Revised Tower Façade Design - North Facade Glare

## Response to Glare issues on the Commercial and Residential North Facade

B4N - Commercial & Residential North Elevation, NTS

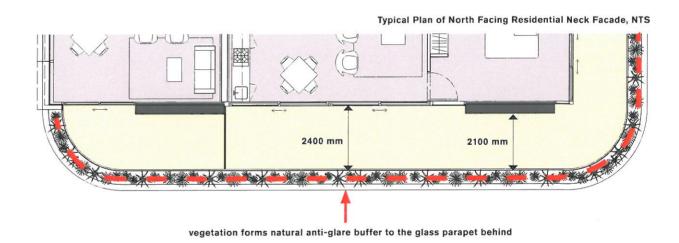
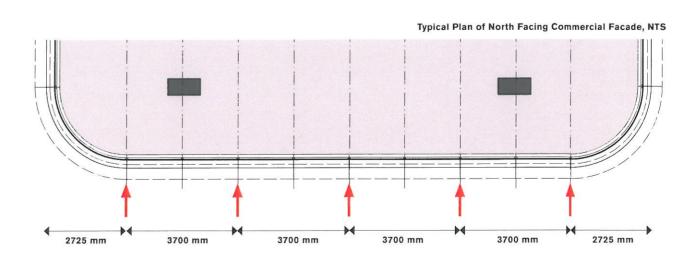
On the northern façade, vertical fin elements to glazing have been recommended to intercept morning and afternoon solar rays reflecting onto Broadway (see Solar Reflectivity Assessment 4946 for Frasers Broadway, submitted in March 2009 by CPP).
